Design and Visual Communication

AS 91338

Exemplar B - Excellence

AS91338: Produce working drawings to communicate technical details of a design (4 credits)

TITLE: FLOOR PLAN

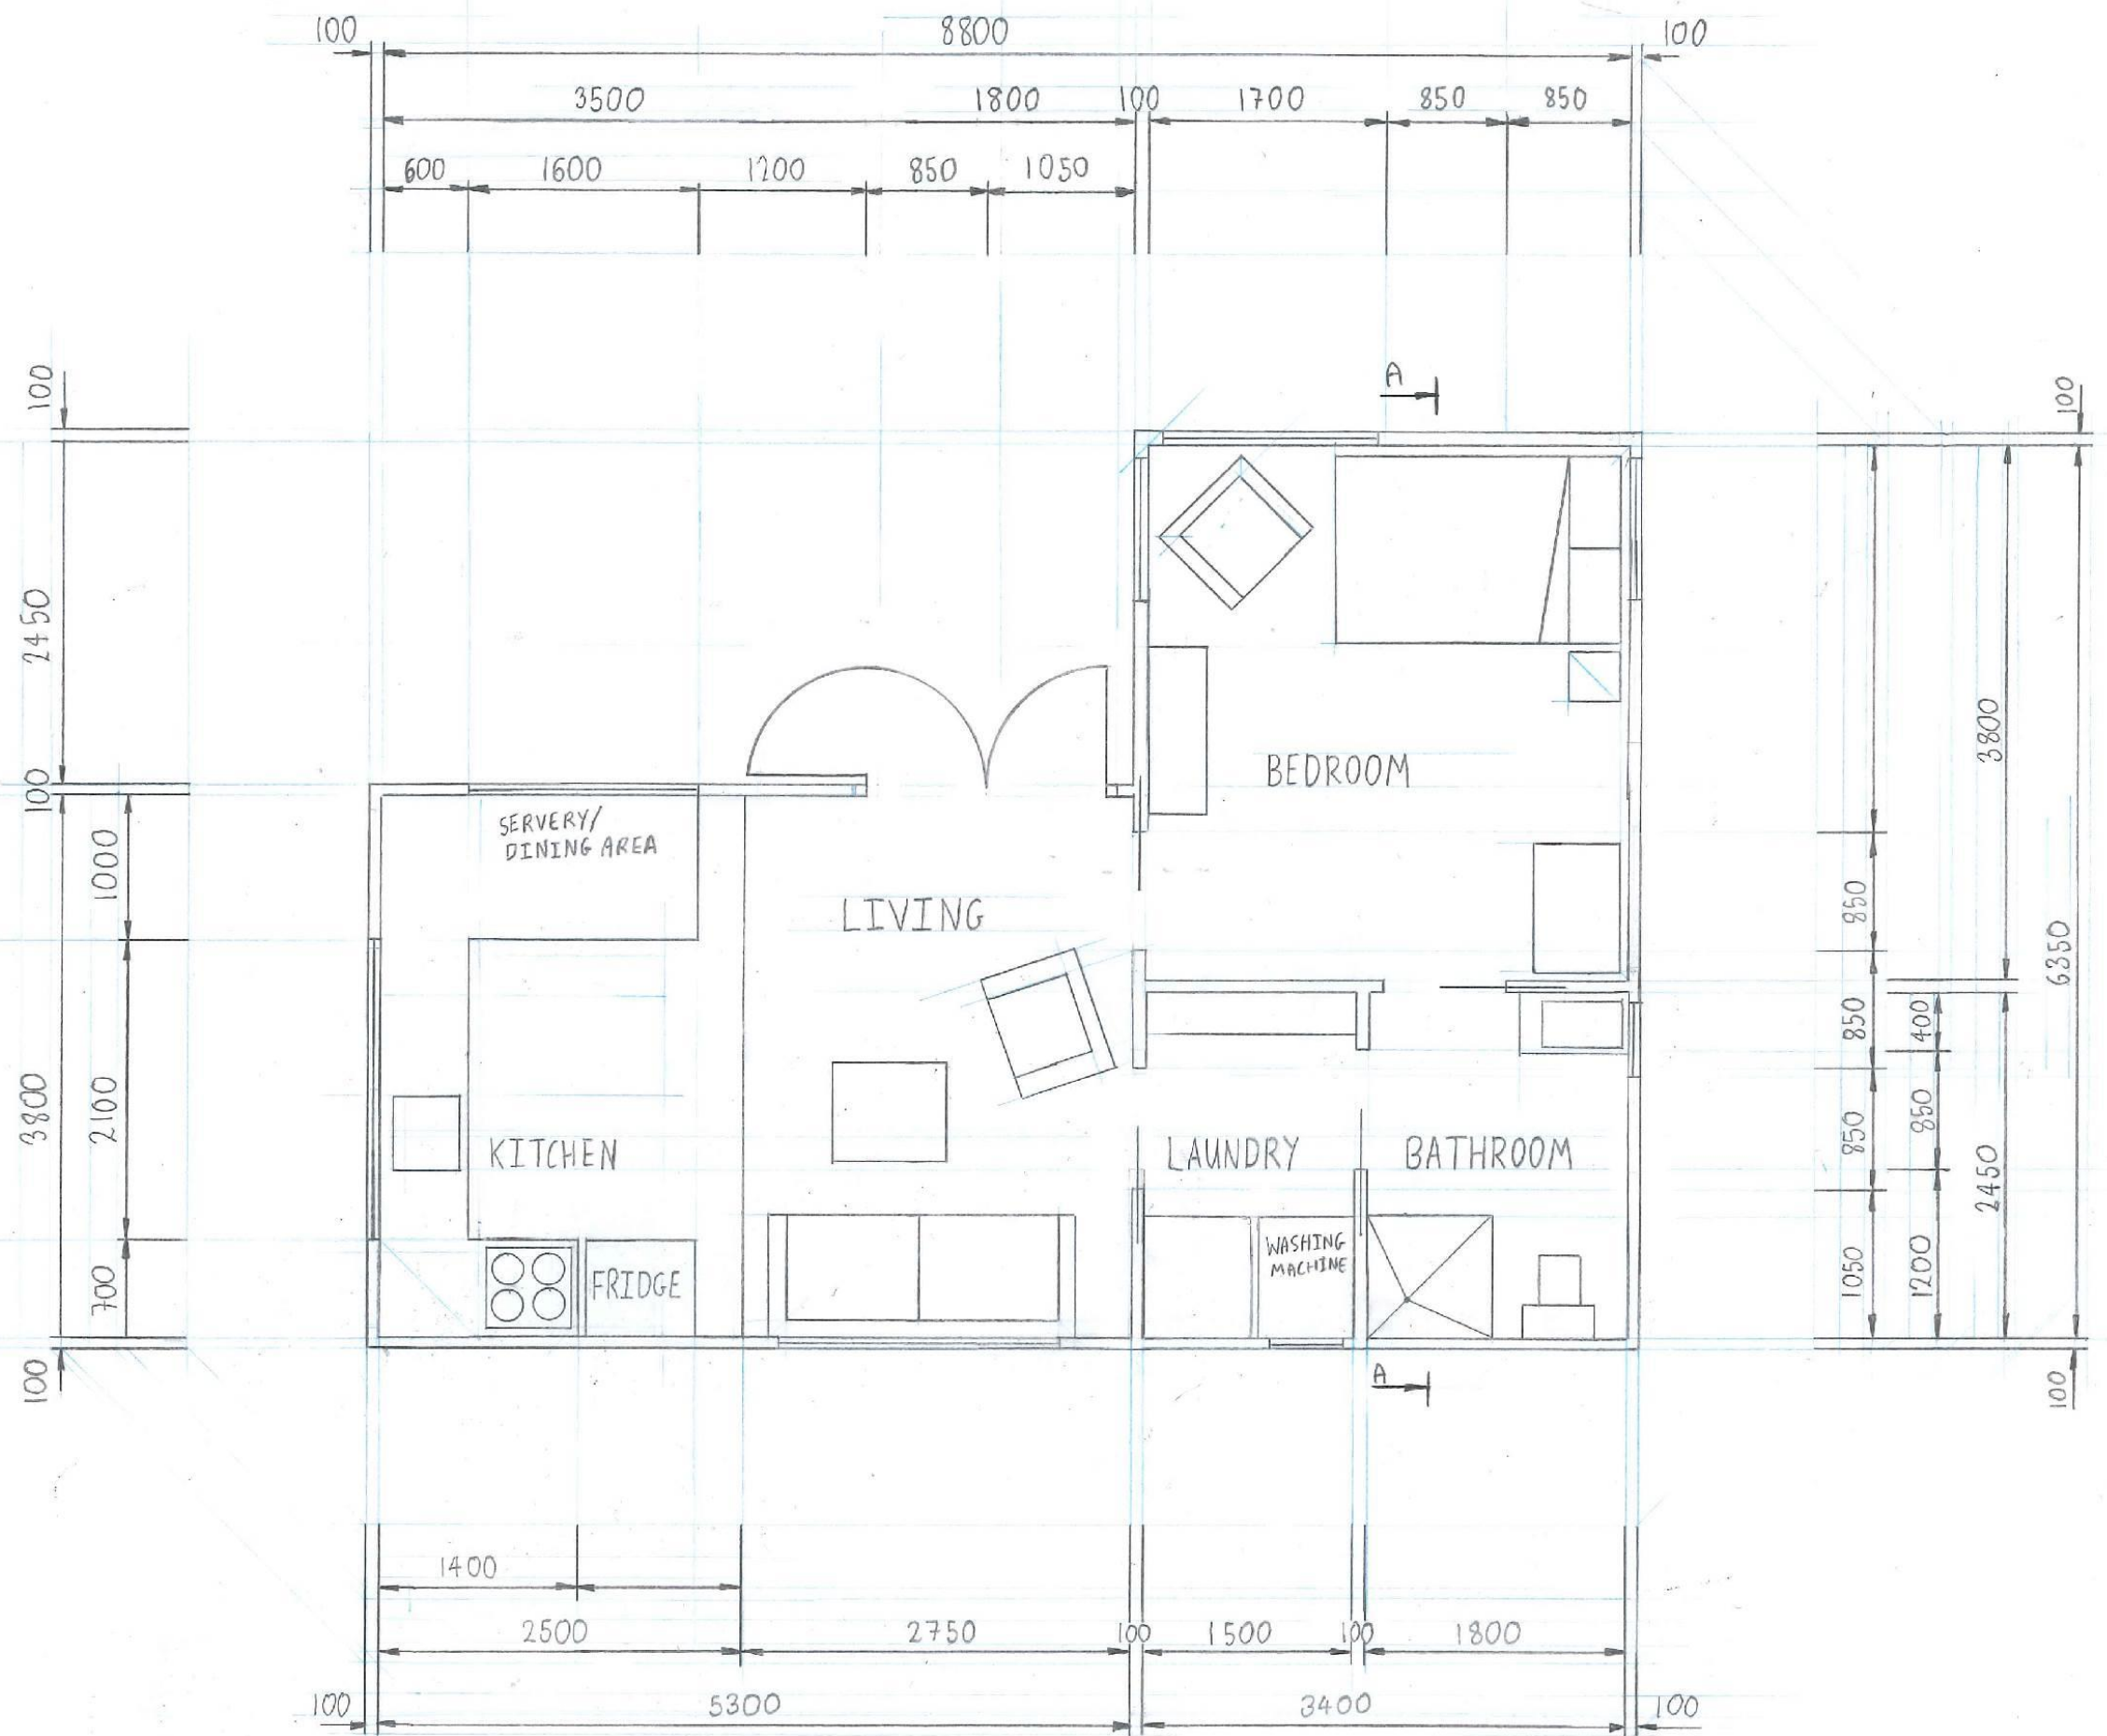
The plan view clearly communicates technical details in the form of room fittings, door swings and windows. The elevations clearly indicate exterior materials, windows and doors. Because the cross section is drawn at 1:20 it clearly and effectively shows the construction of the building.
